HISTORIC AND DESIGN REVIEW COMMISSION

HDRC CASE NO: 2016-327
ADDRESS: 1935 W WOODLAWN
LEGAL DESCRIPTION: NCB 1964 BLK 2 LOT 8
ZONING: R6 H
CITY COUNCIL DIST.: 7
DISTRICT: Monticello Park Historic District
APPLICANT: Mary Valenzuela
OWNER: Mary Valenzuela
TYPE OF WORK: Addition
REQUEST:

The applicant is requesting conceptual approval to construct a 380 square foot addition in the rear.

New
20x10

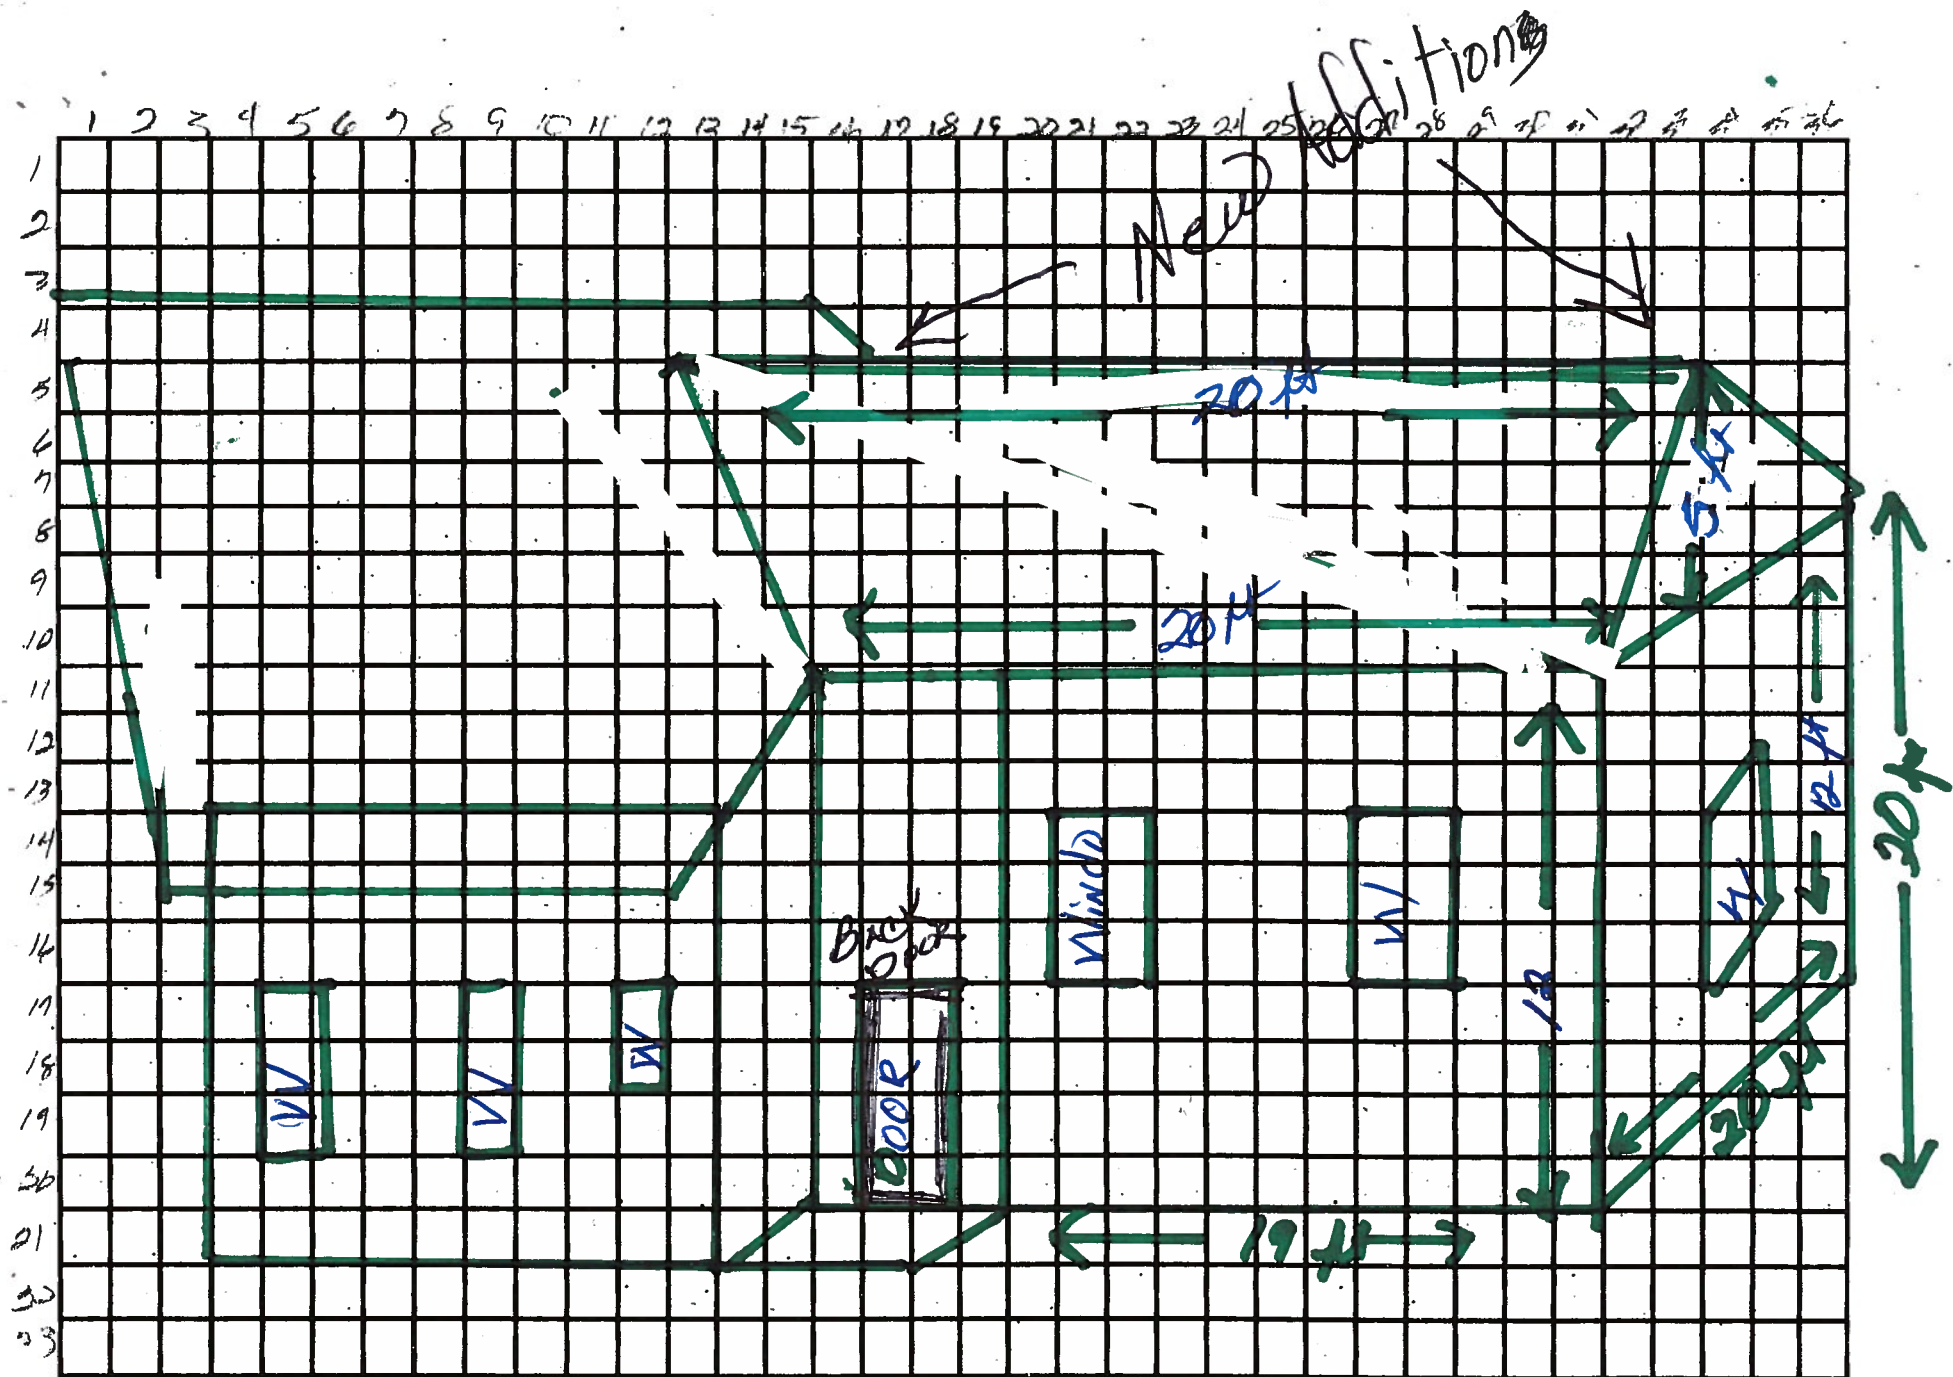
- c. **TRANSITION** – The existing structure is has a front gable on a side gable roof, and wood siding and composition shingles. The applicant is proposing to construct an addition at the rear of the original structure. The applicant is proposing to have the addition flush with the existing structure on the left and right sides. According to the Guidelines for Additions 1.A.iv., additions should feature a transition between the old and the new. The applicant has not proposed to have a reveal, inset or vertical trim indicating the transition from the old to the new. Staff finds this transition consistent with the Guidelines.

- d. **SCALE, MASSING, FORM** – On the rear, there is a side gabled roof and there is an existing detached garage. The proposed addition has a rear facing gable and appears to be below the existing ridge line in the provided renderings. According to the Guidelines for Additions 1.A., additions should be sited to minimize visual impact from the public right of way, utilize a similar roof form, and have a height consistent with the primary structure. Staff finds the proposed addition will not negatively impact the public right-of-way, and the proposed height, scale and form are consistent with the Guidelines, however staff recommends that the ridge height of the addition be below the existing ridge and be detailed in the drawings when the applicant come back for final approval.

1. That the applicant show details of a transition between the old and the new in the final approval application.
2. That the ridge height of the addition be below the existing ridge and be detailed in the drawings in the final approval application.
3. That the applicant submit photos and details of the hardiboard to be installed with the final approval application.
4. That the existing rear windows be salvaged and used in the addition and that the additional windows to be installed have a traditional dimension and profile, be recessed in the window frame and not have false divided lights.

SELECTING WINDOWS FOR NEW BUILDINGS

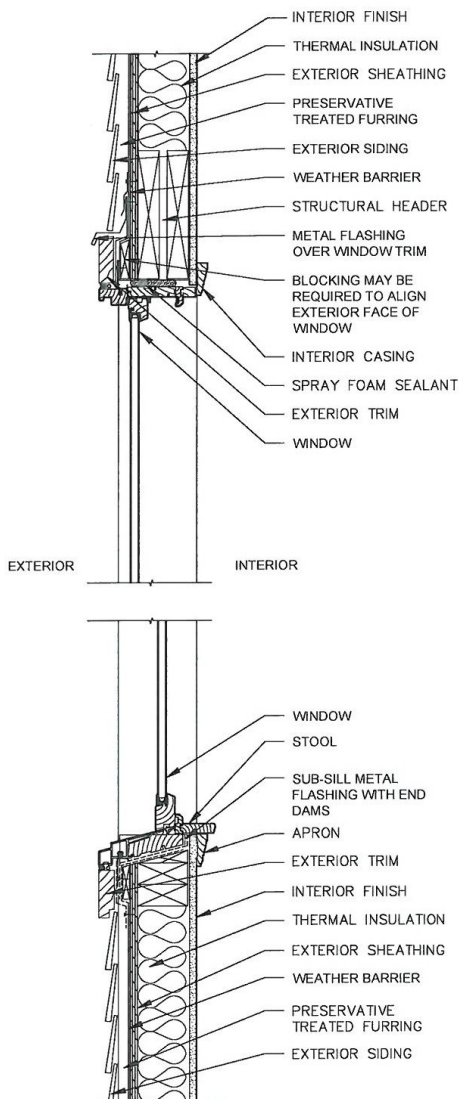
- g. **WINDOWS** – The existing structure has steel casement windows. The applicant has noted the installation of 4 vinyl windows with false divided lights. According to Guidelines for Additions 4.A., window details should correspond with the architectural style of the original structure. Staff finds the proposed windows match the

proportions of the existing but do match the existing material or configuration. The proposal is not consistent with the Guidelines. Staff recommends that the applicant salvage the two existing rear windows and use them in the proposed addition and install windows that block frame windows with traditional dimension and profiles and be recessed within the window frame.

- Maintain traditional dimensions and profiles;
- Be recessed within the window frame. Windows with a nailing strip are not recommended;
- Feature traditional materials or appearance. Wood windows are most appropriate. Double-hung, block frame windows that feature alternative materials may be considered on a case-by-case basis;
- Feature traditional trim and sill details. Paired windows should be separated by a wood mullion.
